Project Submittal Interim Form

Interstate 40 Widening & Improvements (I-4739 I-5111)

Cover letter and revised permit drawings for changes to impacts at permit site 55

Subject: **Modification Request for Section 404 Individual Permit, Section 401 Water Quality Certification and Neuse Riparian Buffer Authorization** for Interstate 40 Widening and Improvements from I-440/US 64 (Exit 301) to just north of SR 1525 (Cornwallis Road), including improvements to NC 42 and SR 1010 (Cleveland Road) in Wake and Johnston Counties, Federal Aid Project No. IMNHF-040-4(139)301; TIP Numbers I-5111 and I-4739, Division 5. Debit \$570 from WBS Element 42346.3.1.

PERMIT DRAWING
SHEET 7 OF 125

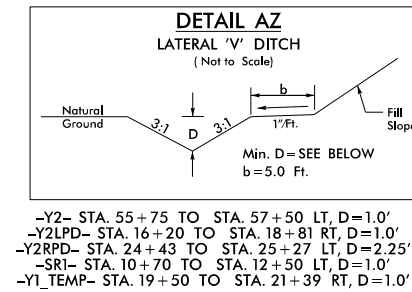
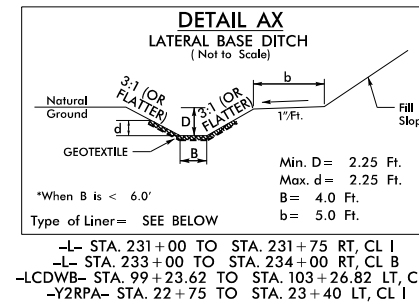
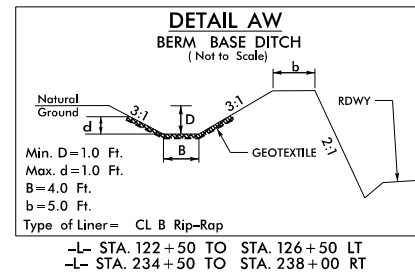
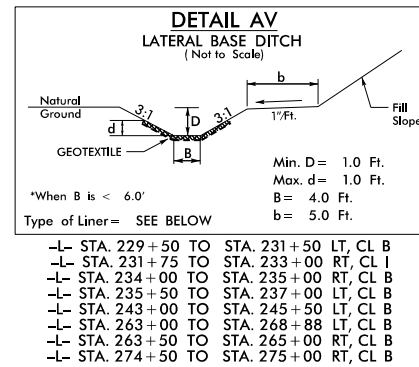
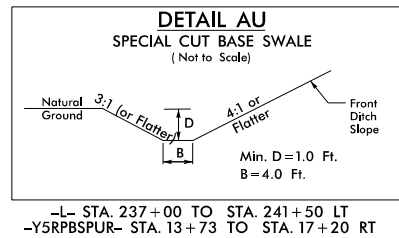
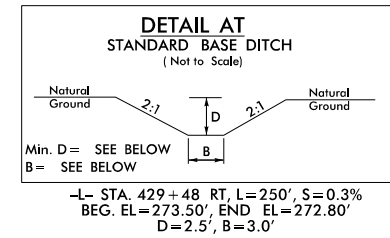
Site 55: Due to repeating erosion events and the general instability of the channel below the outlet of Site 55, the Design Build Team proposes rip rap be added to the flow line to match the length of the previously permitted bank stabilization. This will result in the following changes:

- Permit Drawing 7: Ditch detail sheet
- Permit Drawing 111: plan sheet 49 without contours
- Permit Drawing 112: plan sheet 49 with contours
- Permit Drawing 125: summary table
- Buffer Drawing 41: buffer plan sheet 49

- 40 linear feet decrease in bank stabilization impacts
- 40 linear feet increase in permanent stream impacts
- No changes in buffer impacts
